# Program Bulletin

## CUSTOMER SATISFACTION PROGRAM

**SUBJECT:** Material over Sensing & Diagnostic Module Retaining Moisture

**MODELS:** 2007-2009 Chevrolet Silverado  
2007-2009 GMC Sierra

2348430

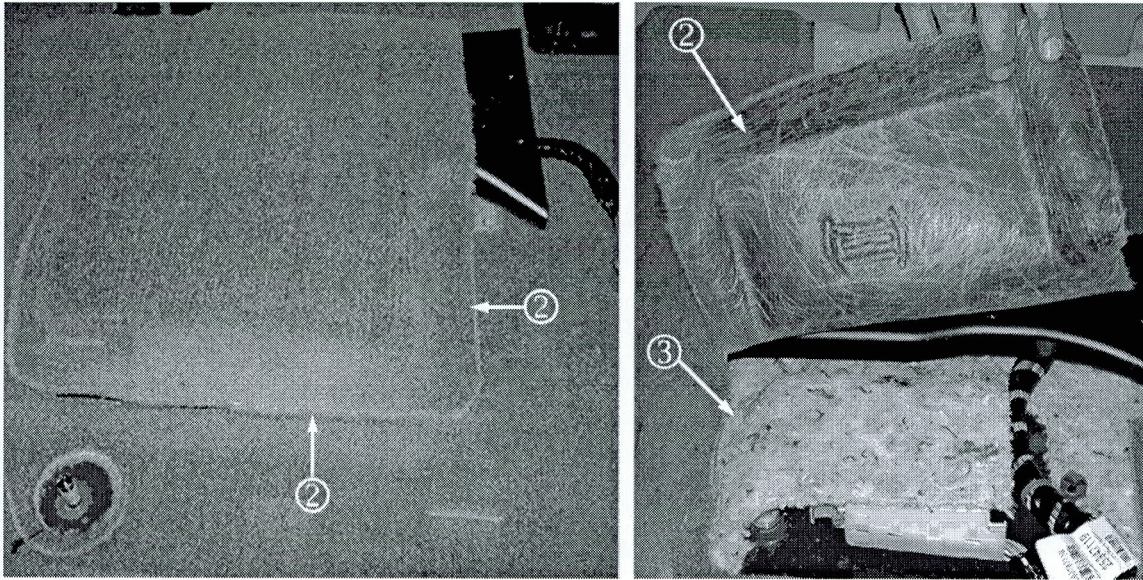
1. If the vehicle is equipped with vinyl flooring and no cutout flap under the driver's seat, no further action is required. For all other vehicles, proceed to Step 2.

**Note:** Driver seat removal is NOT required for crew cab or extended cab vehicles. Certain 2009 regular cab vehicles built after approximately March 1, 2009 with carpet that has a 2-sided cutout over the SDM, however, will require driver seat removal. Refer to *Front Seat Replacement-Bucket* in SI. After the seat removal, proceed to Step 2 in the bulletin. Regular cab vehicles with carpet that has a 3-sided cut over the SDM do NOT require seat removal.

2348422

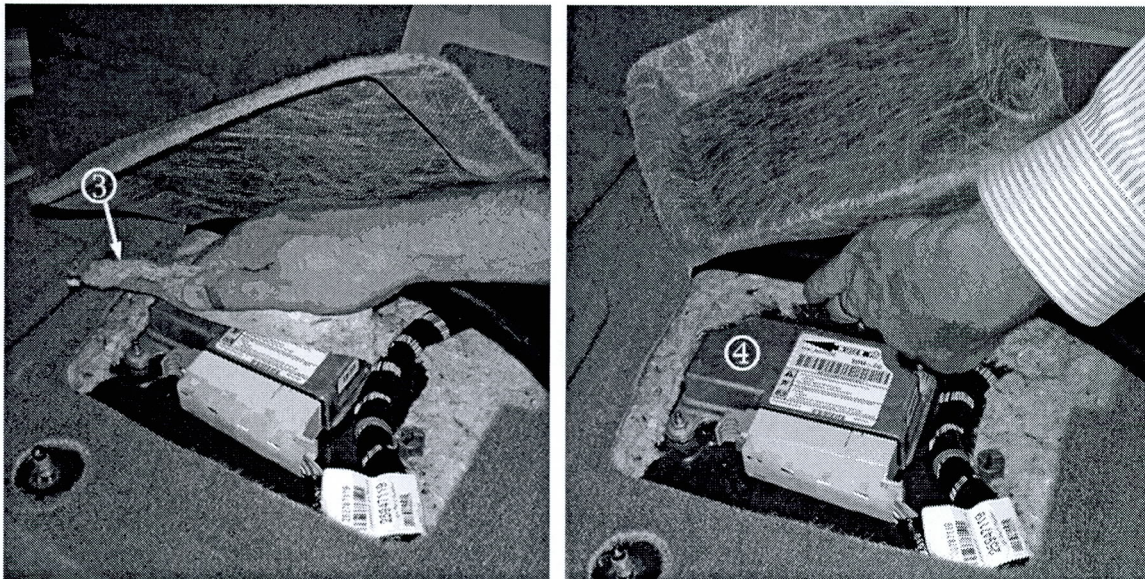
Carpet and cutout flap (2) shown with the driver's seat removed from the vehicle for illustration purposes only. Seat removal is NOT required to gain access to the acoustical pad (3).

3. Lift the cutout flap (2) in the carpet or vinyl to gain access to the acoustical pad (3) that covers the SDM.
